The Great Grid Upgrade

Sea Link

Volume 9: Examination Submissions

Document 9.34.5: Applicant's Response to Selected Relevant Representation Responses

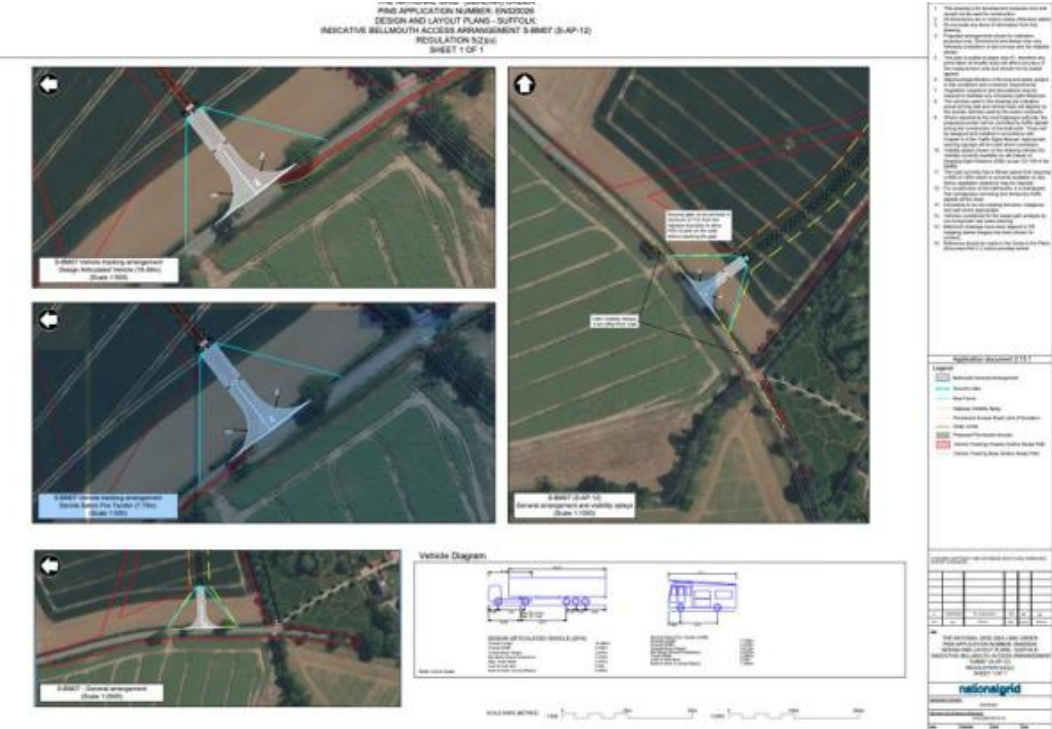
Traffic and Transport – Friston Village	68. There is a serious risk by designating the B1121 through Friston as an HGV route that it will be used by more than the forecast amount. This would appear to be National Grid's intention as they are looking to create a major road junction on the B1121 as set out in the design and layout plans. This junction will also incorporate parking for HGVs. The relevant design and layout plan is reproduced below.	The overall routing strategy is designed to minimise construction vehicles along alternative less suitable routes such as the B1121 Saxmundham Road through Friston. A maximum of two HGVs (four movements) per day are expected along the B1121 Saxmundham Road through Friston to access existing Overhead Line towers (via access S-BM11), as shown by Application Document 6.3.2.7.G ES Appendix 2.7.G Traffic Flow Diagrams [APP-128] and Application Document 6.3.2.7.H ES Appendix 2.7.H Preliminary Highway Impact Assessment [APP-129]. As the proposed construction traffic forecasts through Friston are very low, no impacts are anticipated along

Traffic and Transport – Friston Village	69. This bell mouth arrangement is completely out of proportion with what is effectively a country lane. This is only to be the entrance for the operational access road which will only be needed to be used by LGVs during operation. It is of course notable that access will be necessary for fire engines which is relevant to the safety comments in paragraphs 77 and 78 below.
---	--

The proposed access on the B1121 (S-BM7) referenced has been designed to accommodate the limited number of HGVs which will be required to access the site during its operational phase. As agreed previously with SPR this access would not be used for construction. The access is not expected to be intensely used by HGVs.A Stage 1 Road Safety Audit (RSA) has also been carried out on the proposed access, and any accepted recommendations will be addressed as part of the detailed design. In addition, **Application Document 7.5.1.1 Outline Construction Traffic Management and Travel Plan – Suffolk [APP-337]** outlines management measures to further reduce the potential impacts of HGV deliveries to the site. For example, the contractor(s) will implement a monitoring and reporting system to check compliance with the measures set out within this Outline CTMTP. This will include the need for a GPS tracking system to be fitted to HGVs to check for compliance with authorised construction routes. Deviations from the authorised routes or changes to traffic levels that are higher than the assumptions set out within the **Application Document 7.5.1.1 Outline Construction Traffic Management and Travel Plan – Suffolk [APP-337]** will require discussion with the relevant highways authorities to determine whether additional mitigation measures are needed.

Although the access is not expected to be intensely used by HGVs, HGV movements are expected during the operational phase of the substation. The bell mouth arrangement has been designed to facilitate an articulated vehicle entering and existing the site as demonstrated through the vehicle tracking included on the drawing referenced.
